March 1, 1999

**Re: Conditional Approval of Supplemental Source Control
Containment/Recovery Measures East Street Area 2,
General Electric Company, Pittsfield, Massachusetts
DEP Site No. 1-0146, USEPA Area 4**

***Revised Sheet 4 of Appendix D of the
Supplemental Source Control Proposal***

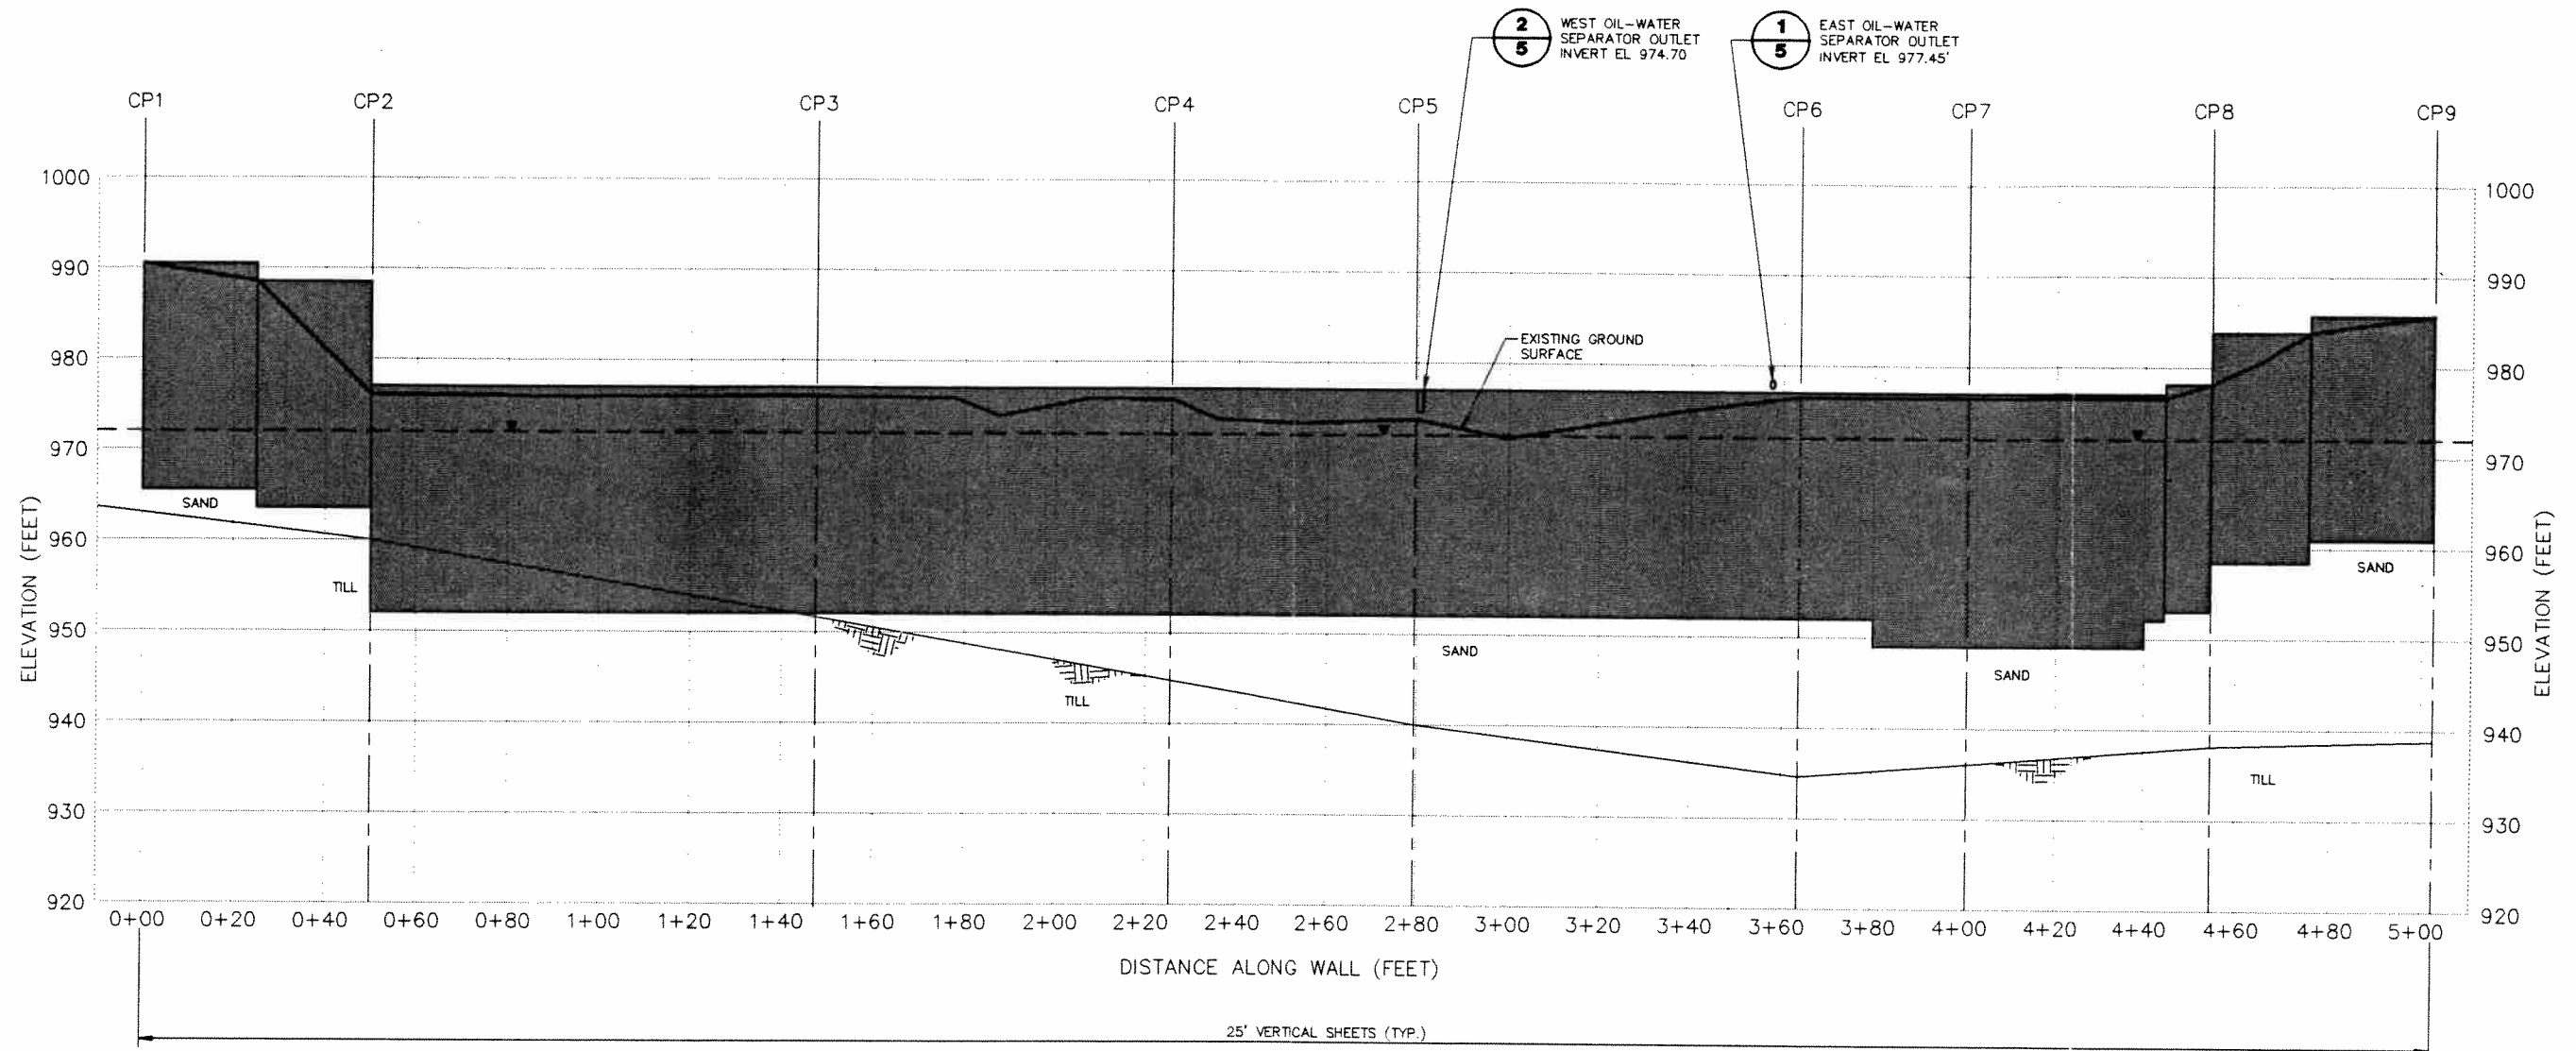
- 1) USEPA requested consideration by GE of the installation of a "heavy-duty woven geotextile or geogrid" beneath the proposed riprap.
- 2) USEPA requested the addition of two notes on Sheet 4 in Appendix D (summarized as):

- 2) GE will incorporate notes to Sheet 4 similar to those suggested by USEPA. A revised Sheet 4 is presented in Attachment 2.
- 3) Section 9.2 of the ½-Mile Removal Action Work Plan includes mitigation measures pertaining to restoration of areas where bank excavations will occur. The riprap backfill planned as part of the proposed sheetpile containment barrier will not result in significant loss of bank or river bed habitats. Riprap will be utilized in an approximate 5- to 6-foot wide strip along the toe of the bank. It will be placed on a slope extending from approximately the top of the sheeting to the edge of the river. The work planned in this area will result only in a temporary absence of bank habitat. GE will evaluate the need for additional restoration activities along this narrow rip-rap strip in the final ½-Mile Removal Action Work Plan.

***Revised Sheet 5 of the Supplemental
Source Control Proposal***

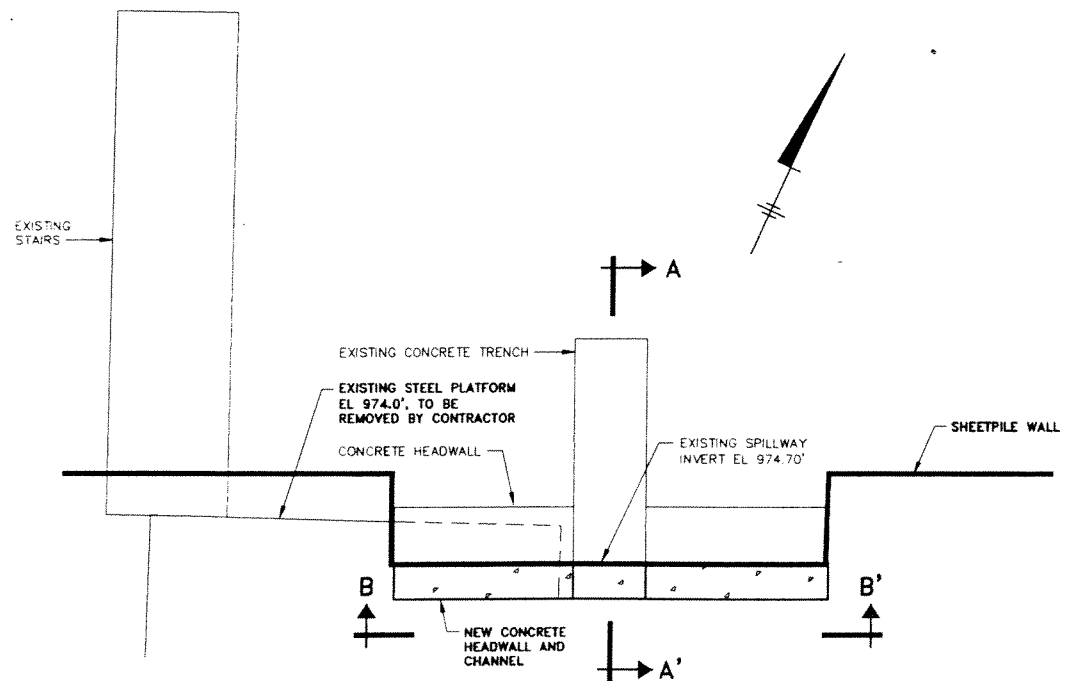
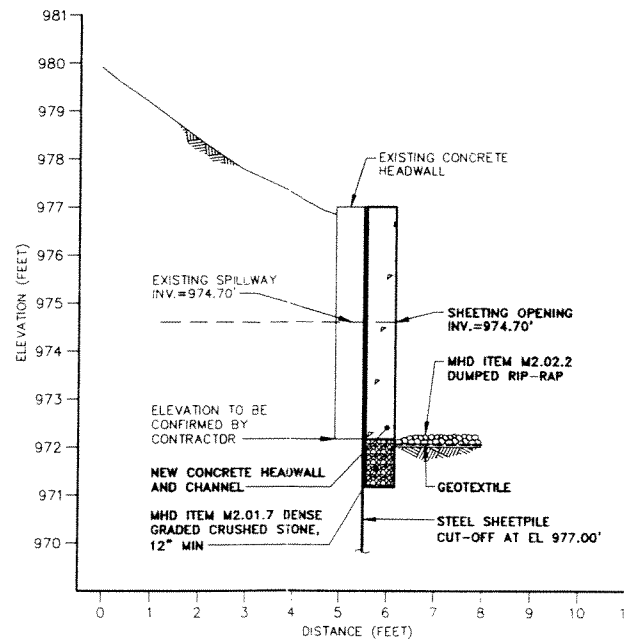
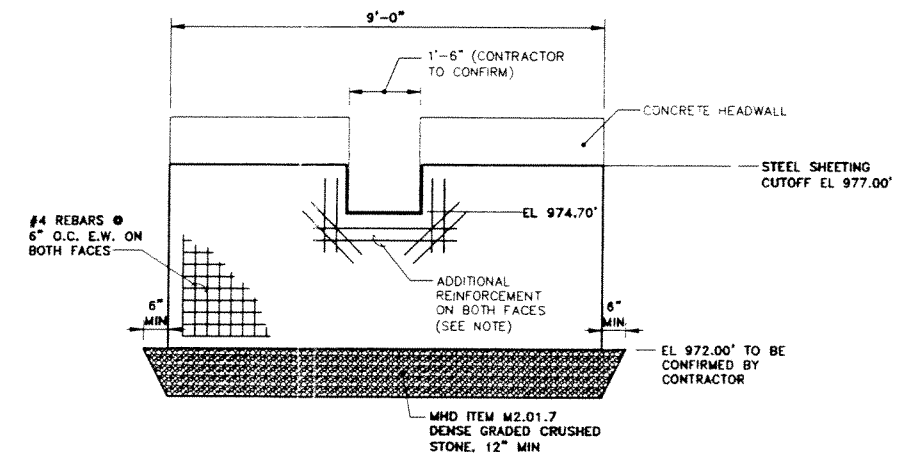
As part of its February 11, 1999 conditional approval letter, the USEPA presented several comments concerning the proposed configuration of the sheetpile wall in the vicinity of the west headwall as presented on Sheet 5 of Appendix D of the Supplemental Source Control Proposal. In general, these comments relate to the integration of the sheetpile wall with the headwall without resulting in permanently exposed sheetpiles along this portion of the river.

In response to these comments, the alignment of the sheetpile wall in the vicinity of the west headwall has been modified to address the USEPA's comments. The modified connection details are shown on Figure 1 and in Attachment 4. Specifically, the sheetpile wall alignment has been changed such that it will extend out flush with the front face of the west headwall, with the use of "L" sections on either side of the headwall. To accomplish this, longer sheets will be used in this area so that the driving hammer will not be obstructed by the existing headwall. The sheets will then be cut flush with the top of the headwall once they have been driven to the desired depth. A new concrete headwall will be constructed on the face of the sheetpile such that the sheetpile will not be exposed. Geotextile and riprap will be placed at the excavated toe of the bank slope as a measure of erosion protection until such time that final excavation and restoration activities are conducted as part of the ½-Mile Removal Action Work Plan activities.
